Safety Notice 130009 (NHTSA RECALL NOTICE 13V-420)

Terex has decided that a defect which relates to motor vehicle safety exists in the outrigger assembly installed on our TZ-34/20 trailer mounted aerial work platform booms.

This recall requires installation of the dual counterbalance valve manifold on your machine.

Illustration 2

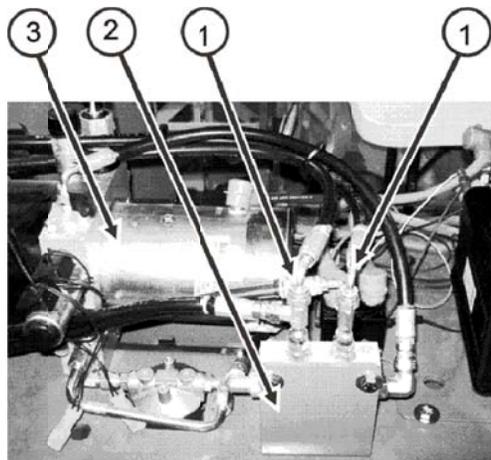
⊙ If the counterbalance valve manifold is equipped with two hose connections on top as shown in illustration 2, your machine is already equipped with the dual counterbalance valve. Fill out the attached completion form and return to Terex AWP Warranty Department. This will verify that you have completed this safety notice.

Illustration 3

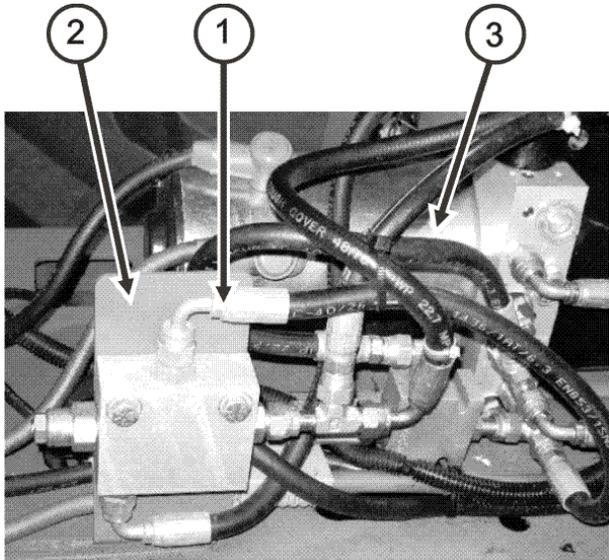
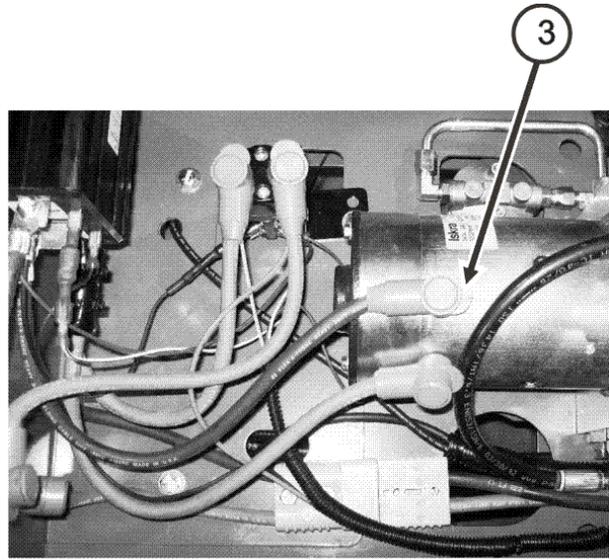
- ☒ If the counterbalance valve manifold is equipped with a single hose connection on top as shown in illustration 3, or the machine is not equipped with a counterbalance valve manifold (illustration 4), order the “Dual Counterbalance Valve Manifold Kit” and install on your machine.

Illustration 5

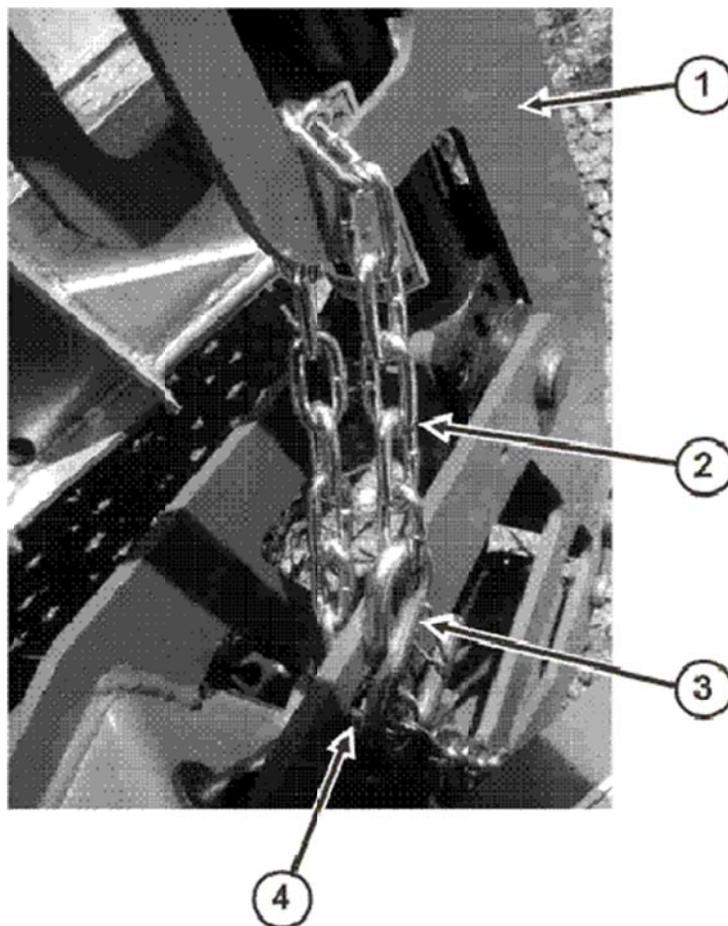
- 1 Secure all four outriggers using a suitable tiedown device i.e a safety chain, strap etc.
- 2 Guide the strapping device through the outrigger arm opening and through the eyelet hole in the chassis.
- 3 Secure the tiedown properly so that it cannot fall off in during transport or while not in use. Illustration 5 shows how a chain with an S-hook, with latch, can be used.
